**RC216016: Foodstuffs South Island (Properties) Limited:
Peer Review of Transportation Assessment and Supplementary Information**

Further to various correspondence, we have reviewed the transportation-related documentation provided in support of the above application by Abley. The reports reviewed are:

Figure 1: Extract from Plan Change 71 Updated Outline Development Plan

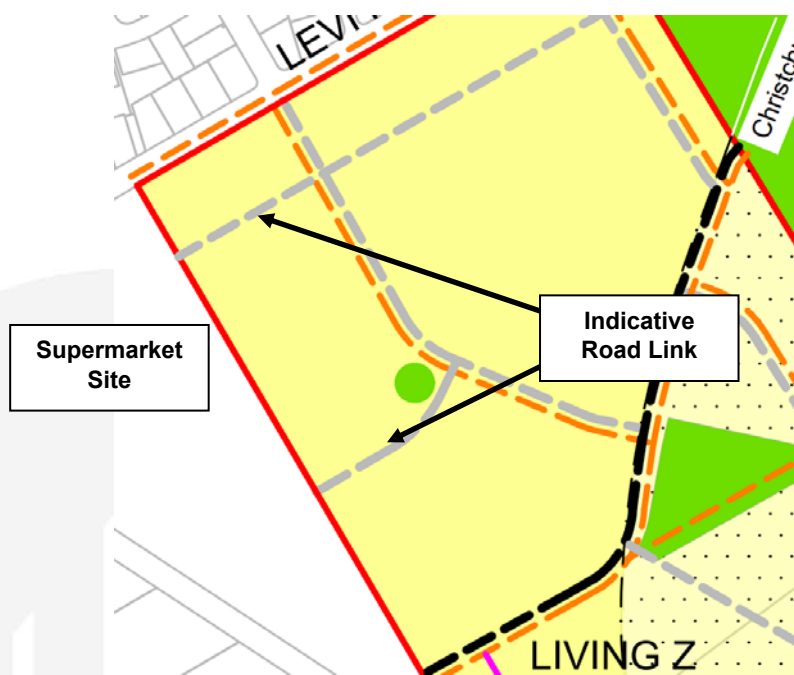
In addition to the swept paths provided in the ITA, additional swept paths were provided within the Transport RFI Response. This was in response to a query about how delivery vehicles could safely over-run the centreline of the road at the southeastern corner of the site. Abley confirmed that there will be "*restricted access*" in this location, which we anticipate as meaning that there will be no members of the public in this area. We are therefore comfortable with the arrangement, but we stress that if the public is not expected to be present, this roadway could not be extended any further eastwards in future. This is relevant to matters arising from PC71, which appears to show a public roading connection in this location.

We agree that the extent of car parking provided will be appropriate (as discussed above) and that if PC71 is recommended for approved (as seems extremely likely), then it will mean that a greater number of people are able to access the supermarket on foot or by cycle. However, part of PC71 shows roading links towards the eastern boundary of the supermarket, and it appears that these could not easily be formed without connecting to the service lane, or by extending the southern east-west route further eastwards (and as noted above, this cannot occur without eliminating the mitigation that Abley has relied upon associated with larger vehicles crossing the centreline).
